## Response to Raymond Fire Department Memo

**Re: Raymond Fire Department Plan Review Memo (dated 8/5/21)**

RAYMOND SOLAR PROJECT  
DENS DRIVE PRIVATE WAY  
PLAN AND PROFILE

RAYMOND SOLAR

## C-6.0

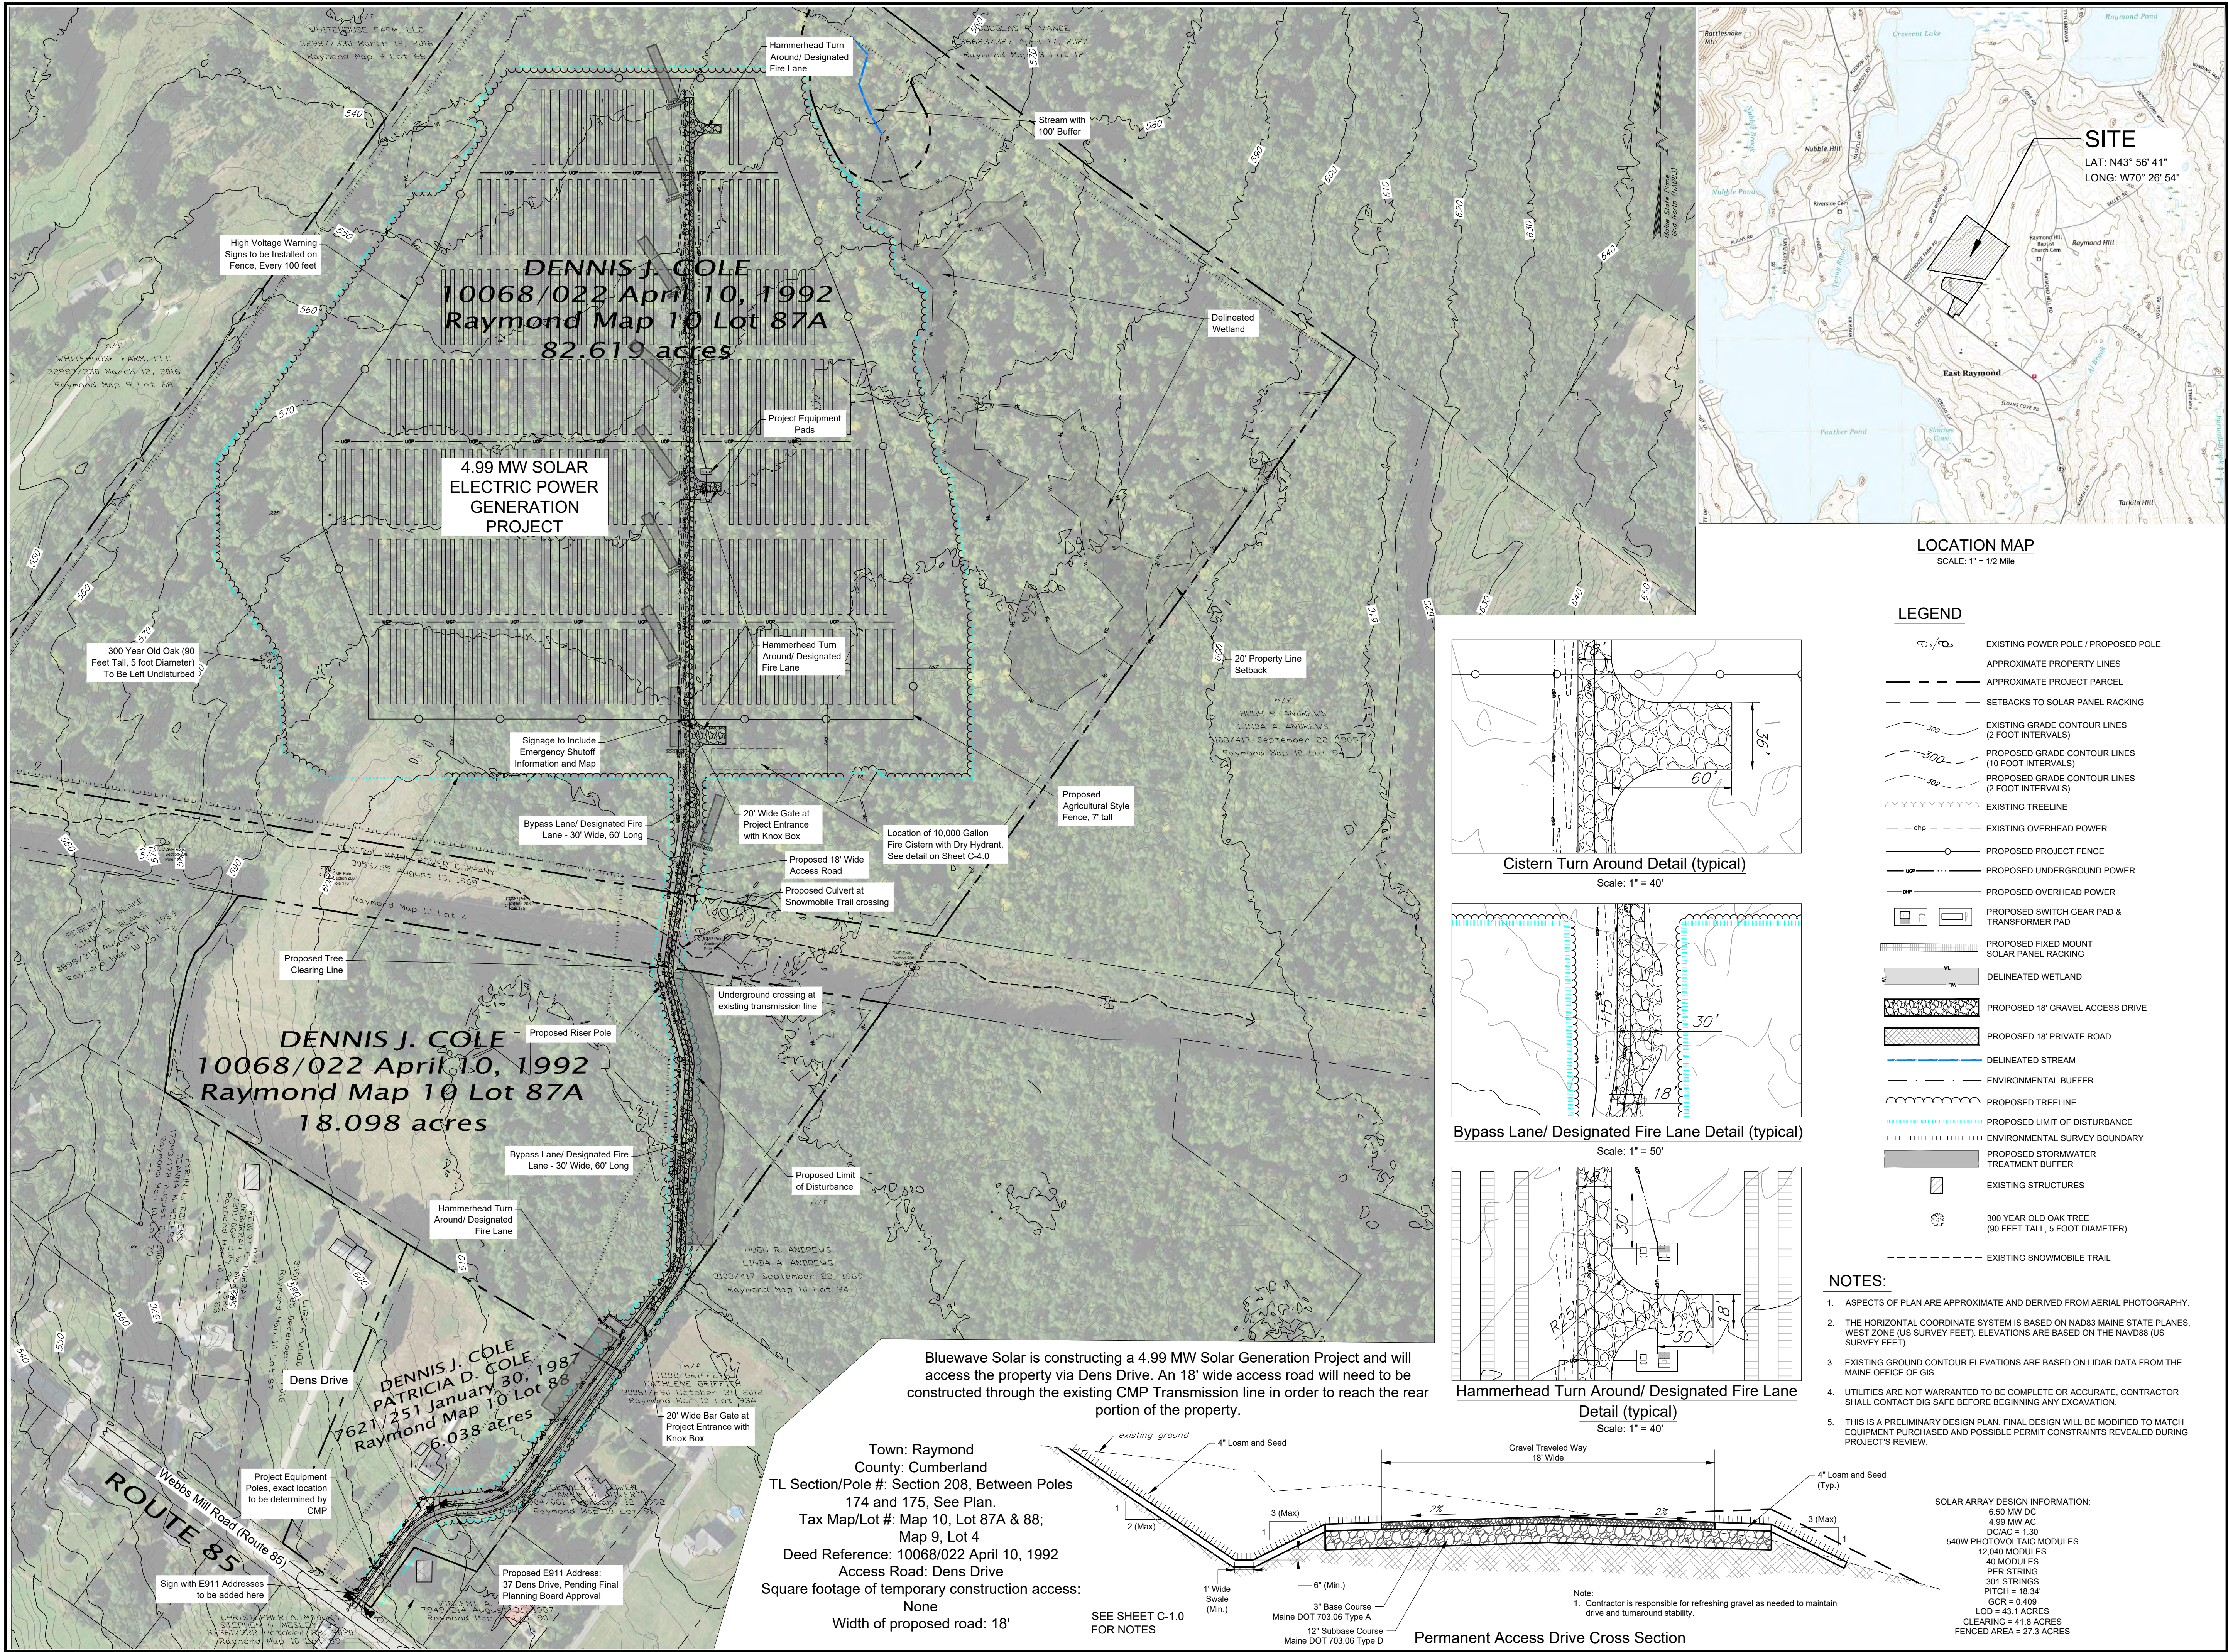
You had also requested that we create a separate Private Way Plan for submittal, and to make sure it conformed with local ordinances. We appreciate the feedback that you were able to provide, and the final version that includes updates to the comments you gave us is included in this packet.

1. The application should address Fire Rescue Department access in accordance with NFPA 1, Chapter 18.
  - a. Fire Rescue Department access shall be provided around the entire fenced in solar array complex with 18-foot fire access roads in accordance with town standards for private roads.

- b. The fire access road within the solar array grid system shall be extended in a northerly direction approximately 750 feet to the northern extent of the solar grid. This extension should interconnect with a fire access road that will encircle the entire solar grid complex. The intersection of these access roads should incorporate the necessary turn radii for RFRD apparatus.

- Section 1: NFPA 1, Chapter 18 Requirements
  - The project is proposing a 18ft wide road in the private way and access road outside and inside the fence.

- Additionally, the road within the fence has been extended to the northern area of the project to provide vehicular access to the northern and southern limits of the solar panels.

- All hammerhead turn around conform to the newly approved Raymond road standards (18ft wide). A radius of 25ft and hammerhead length of 30ft
- The Project is proposing a Private Way Plan to establish the required road frontage for the project. As discussed, the simplest solution is to extend Dens Drive into the Project area, and then request a E911 address for the Project. Our team has been communicating with Kaela Gonzalez and is awaiting a final assigned number. Once provided, the site plan will include the actual E911 address.
